## **SB, New Blade support, LB553S, LB553Se, LC48, LC348V, -VE, -VI, LC53, LC353V, -VE, -VI, LB48, LB348V, -VE, LB448S, LB548Se, 2016-01**

A new blade support will be introduced in production and as spare part. The old version could wear out the belt / pulley and cause the belt to slip.

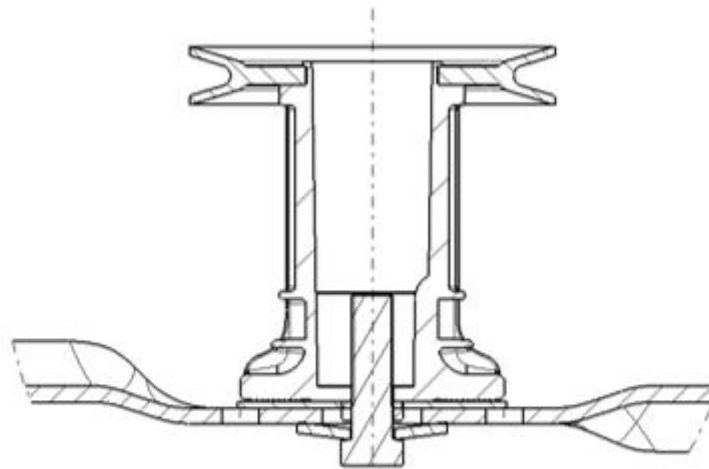
The new blade support is made of a different material (steel pulley) which will solve the wear issue.

The new LB553 blade support has an integrated pulley with a modified blade attachment which solves the slipping blade issue.

The new blade support kit includes the following parts:

- ✓ Mower blade
- ✓ Blade support
- ✓ Washer (fibre)
- ✓ Spring washer
- ✓ Screw
- ✓ Instruction

The new mulch kit includes the following part:

- ✓ Mulch blade
- ✓ Mulch plug (only for Alpha)
